Access Compliance Report

Public Rights-of-Way

Intersection ID: 10039181	Main Street: SUMNER_HALL_LN	Cross Street: N/A	Location: NE
ADA ID: 22A345FE353D	Ramp Type: PerpDiag	Initial Pass/Fail: Fail	Overall Compliance: No
Severity Score: 8.75			
Codes/Mitigation Info/Possible Solution		Field Measurements/Component Compliance

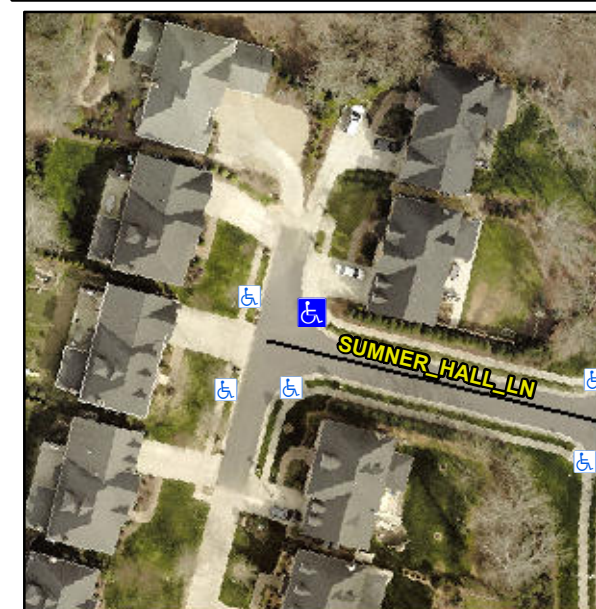
Not Found, R304.5.1

Compliance	Description	Data	Compliance	Description	Data
N/A	Ramp Length (in)	47.0	Yes	Ramp Slope (%)	6.2
No	Ramp Width (in)	46.5	Yes	Ramp XSlope (%)	1.7
N/A	Flare Type LT	N/A	N/A	Flare Type RT	N/A
N/A	Flare Slope LT (%)	N/A	N/A	Flare Slope RT (%)	N/A
N/A	Flare Traversable LT?	N/A	N/A	Flare Traversable RT?	N/A
N/A	Landing Length (in)	N/A	N/A	DWS Provided?	N/A
N/A	Landing Width (in)	N/A	N/A	DWS Contrast?	N/A
N/A	Landing Slope (%)	N/A	N/A	DWS Length (in)	N/A
N/A	Landing X Slope (%)	N/A	N/A	DWS Full Width?	N/A
N/A	Landing Curb? (Y/N)	N/A	N/A	DWS Offset (in)	N/A
N/A	Shared Landing?	N/A			
N/A	Gutter Ponding?	N/A	N/A	Gutter Slope (%)	N/A
N/A	Gutter Lip Ht (in)	N/A	N/A	Gutter X Slope (%)	N/A
N/A	Painted X Walk1?	No	N/A	Painted X Walk2?	No
	X Walk 1 Direction	To W		X Walk 2 Direction	To SW
N/A	X Walk 1 Width (in)	N/A	N/A	X Walk 2 Width (in)	N/A
	X Walk 1 Slope (%)	1.3		X Walk 2 Slope (%)	0.9
	X Walk 1 X Slope (%)	2.5		X Walk 2 X Slope (%)	0.7

Remove & Replace Curb Ramp With Two New Directional Ramps or Equivalent.
